Architect's Supplemental Instructions

Architect's Project No:
04561.01

Architect's ASI No: 025

See attached Exhibit A, and the above sheet list for rooms and locations of the point-of-use ANT, acid vent routing, piping diagrams, risers and acid vent through the roof locations.

P0113.A

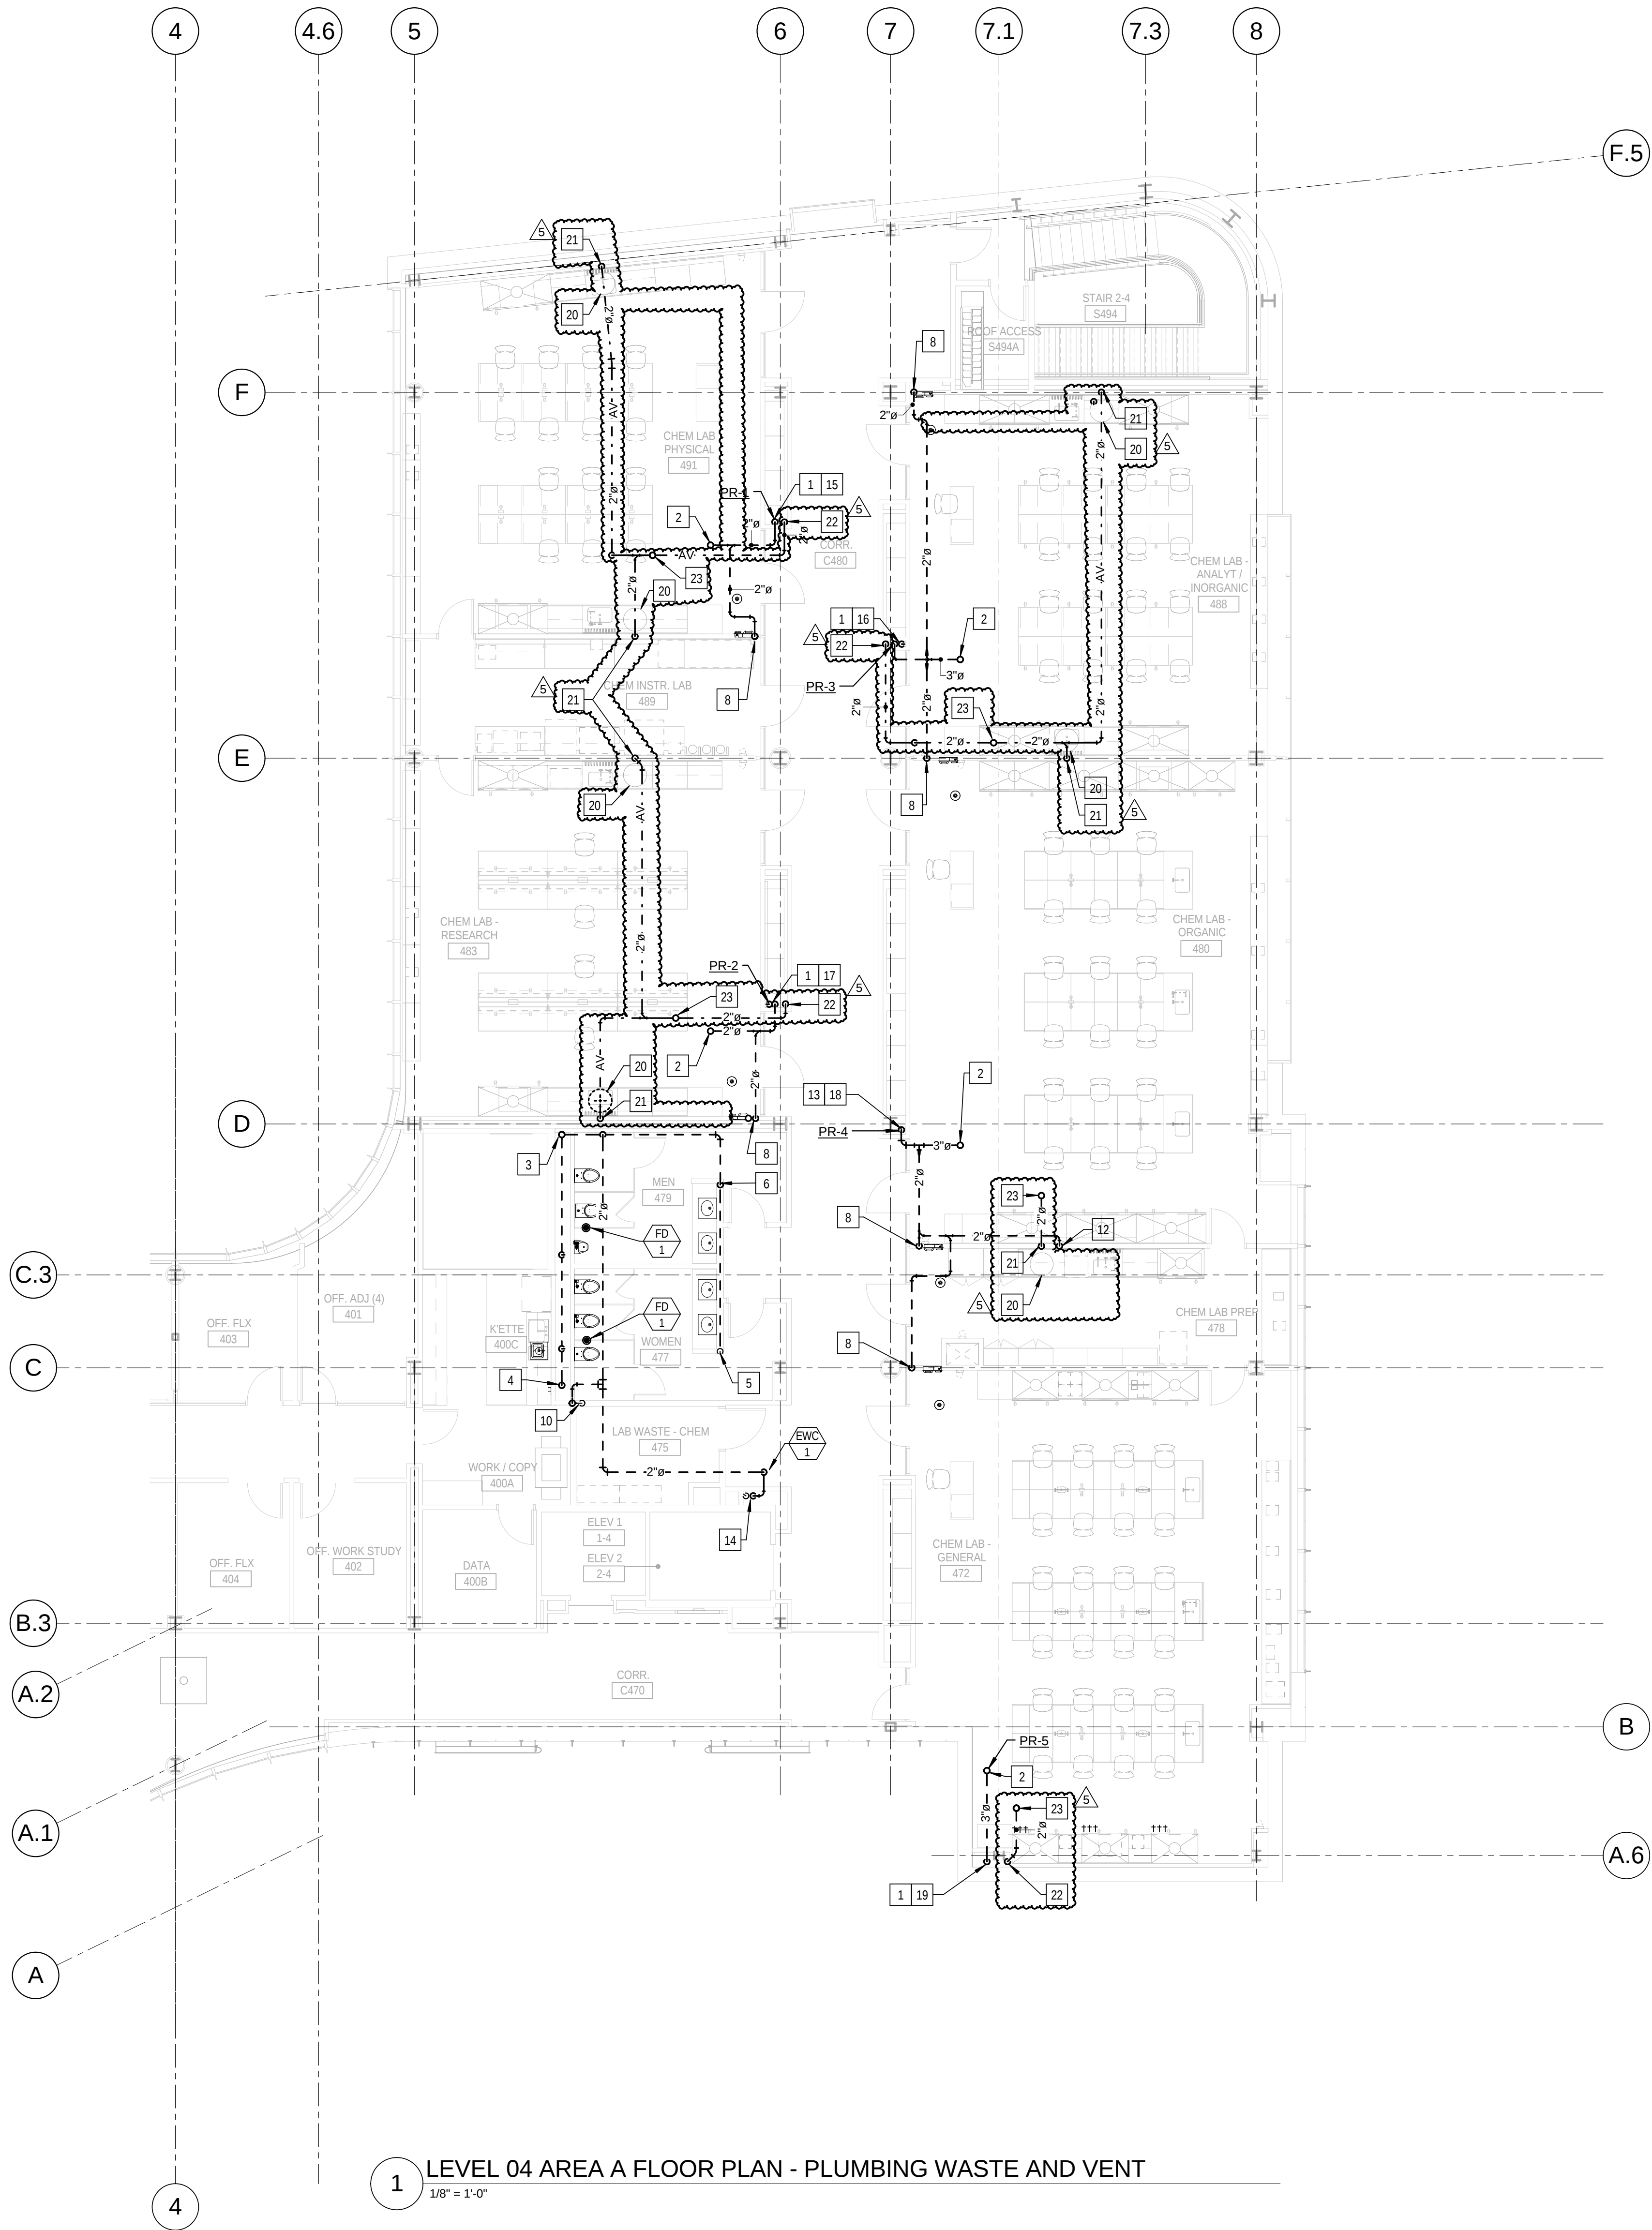
- 18 REFER TO DRAWING P0408 SANITARY WASTE AND VENT RISER DIAGRAM 4-3.
- 19 REFER TO DRAWING P0408 SANITARY WASTE AND VENT RISER DIAGRAM 5-3.
- 20 5-GALLON NEUTRALIZATION TANK WITH SLIP-ON COVER, LOCATED BELOW THE COUNTERTOP. REFER TO DRAWING P0404, DETAILS 1 AND 2 FOR PIPING DIAGRAM INSTALLATION.

P0404

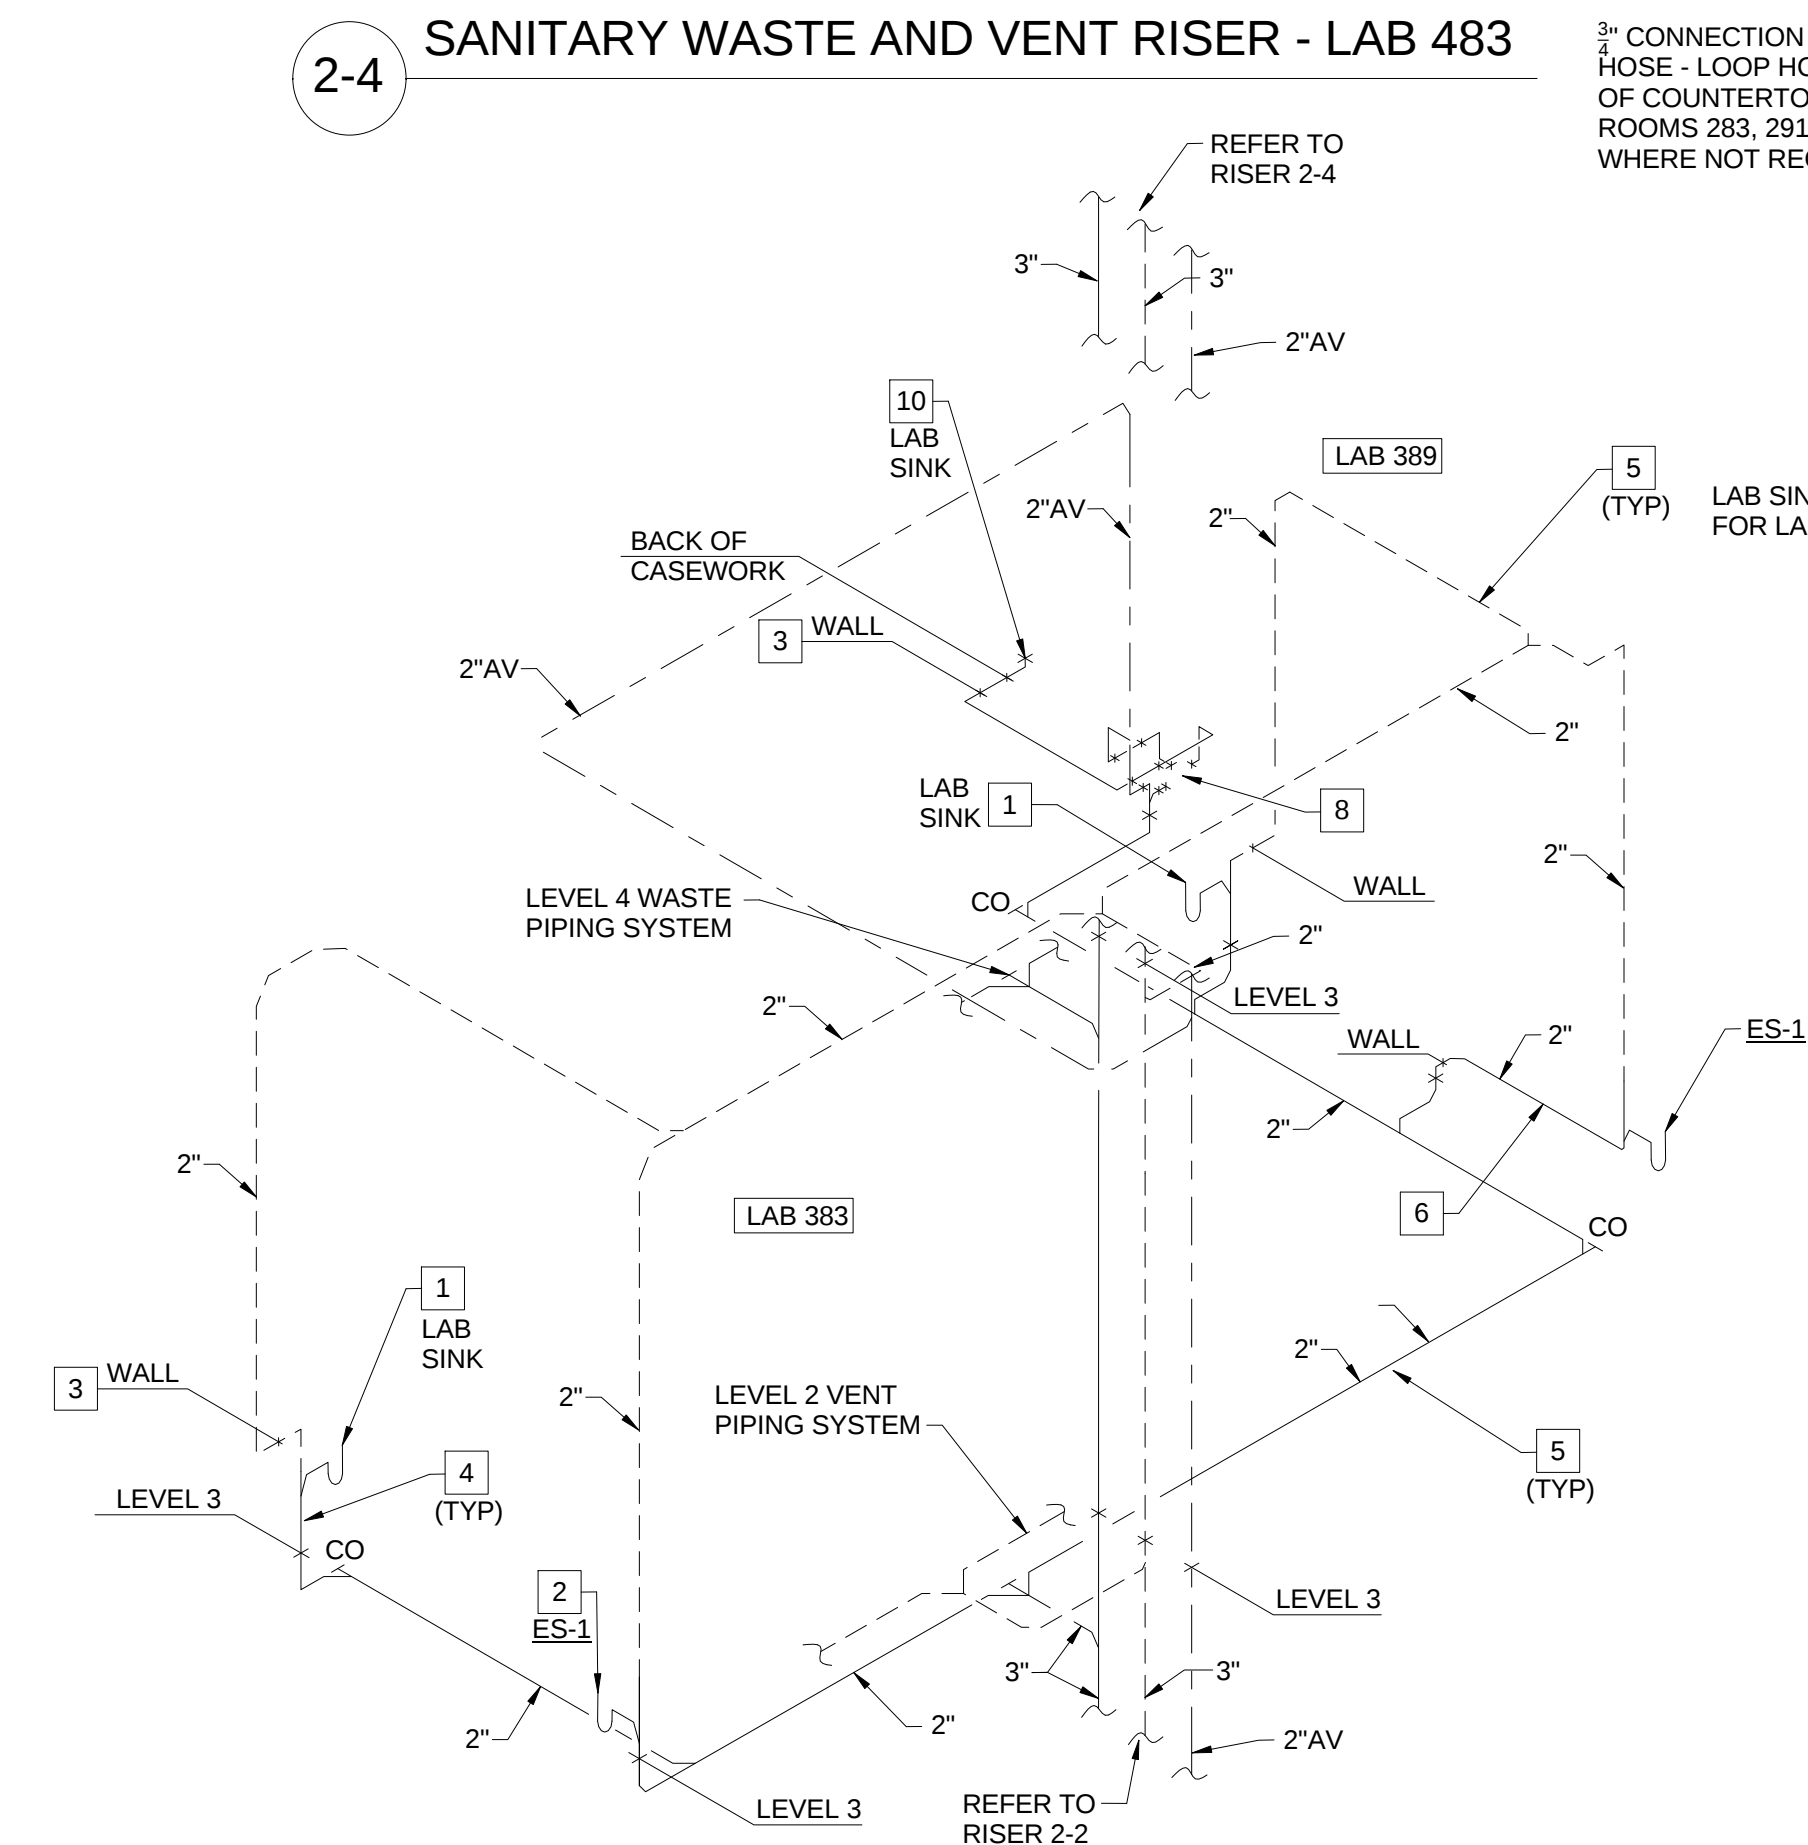
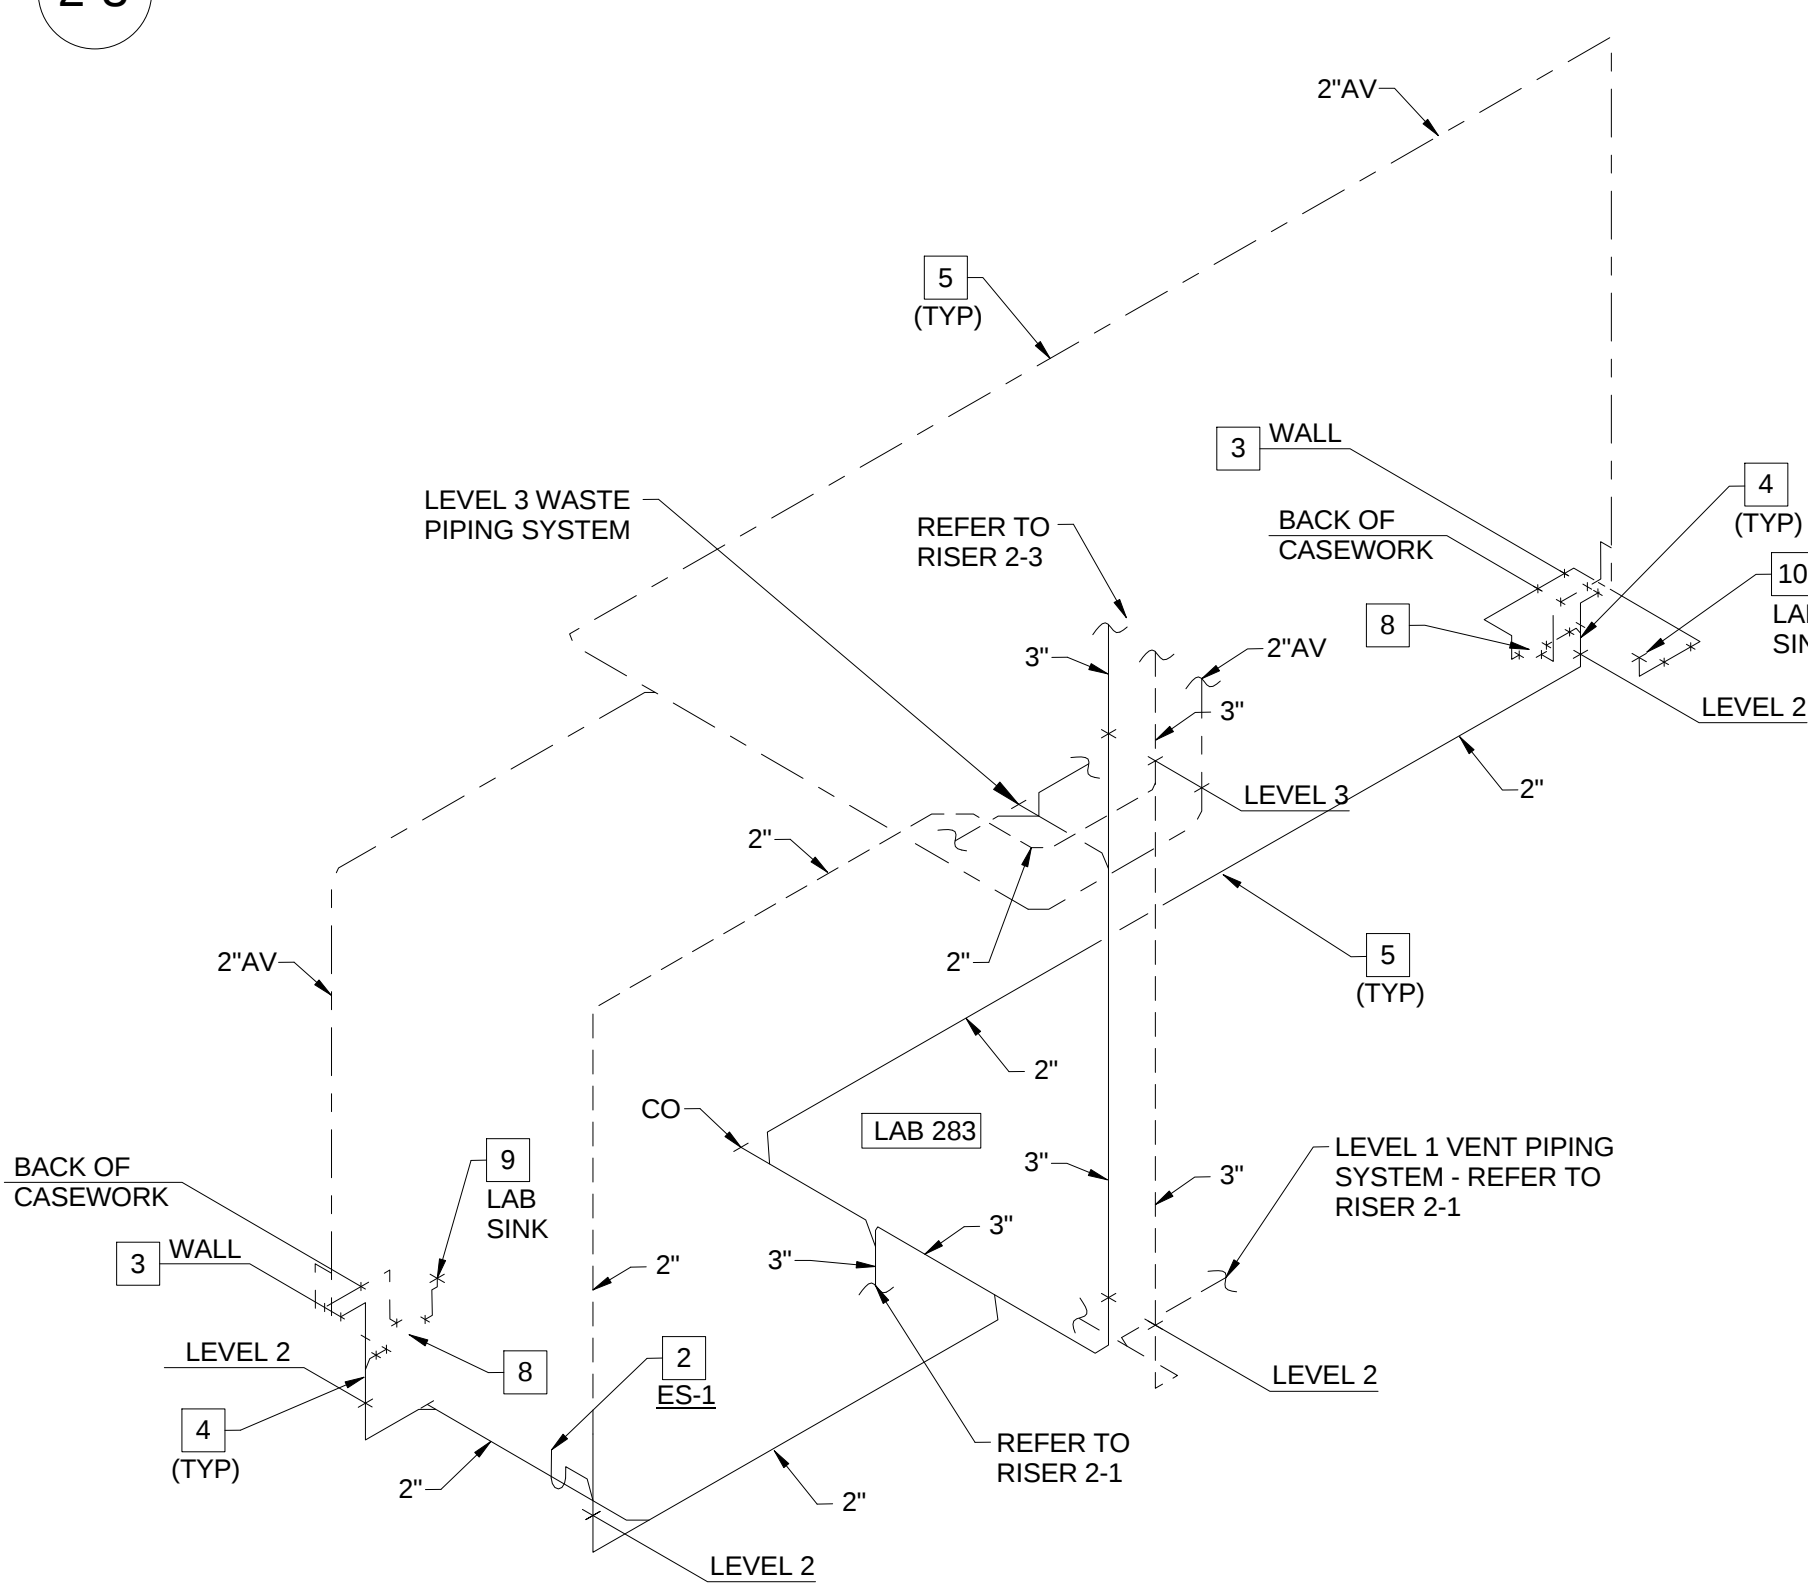
- 7 LAB SINK TO BE CONNECTED TO POINT-OF-USE NEUTRALIZATION TANK REMOTE FROM THE SINK LOCATION. COORDINATE WITH THE ARCHITECTURAL DRAWINGS FOR THE CASEWORK. REFER TO DRAWING P0404, DETAIL 1/P0404 FOR TYPICAL PIPING DIAGRAM. PIPING TO BE ADJUSTED AS REQUIRED FOR EACH LOCATION.

- 9 LAB SINK TO BE CONNECTED TO POINT-OF-USE NEUTRALIZATION TANK BELOW THE SINK. COORDINATE WITH THE ARCHITECTURAL DRAWINGS FOR THE CASEWORK. REFER TO DRAWING P0404, DETAIL 2/P0404 FOR TYPICAL PIPING DIAGRAM. PIPING TO BE ADJUSTED AS REQUIRED FOR EACH LOCATION.

- 10 LAB SINK AND GLASS WASHER TO BE CONNECTED TO POINT-OF-USE NEUTRALIZATION TANK REMOTE FROM THE SINK LOCATION. COORDINATE WITH THE ARCHITECTURAL DRAWINGS FOR THE CASEWORK. REFER TO DRAWING P0404, DETAIL 1/P0404 FOR TYPICAL PIPING DIAGRAM. PIPING TO BE ADJUSTED AS REQUIRED FOR EACH LOCATION.
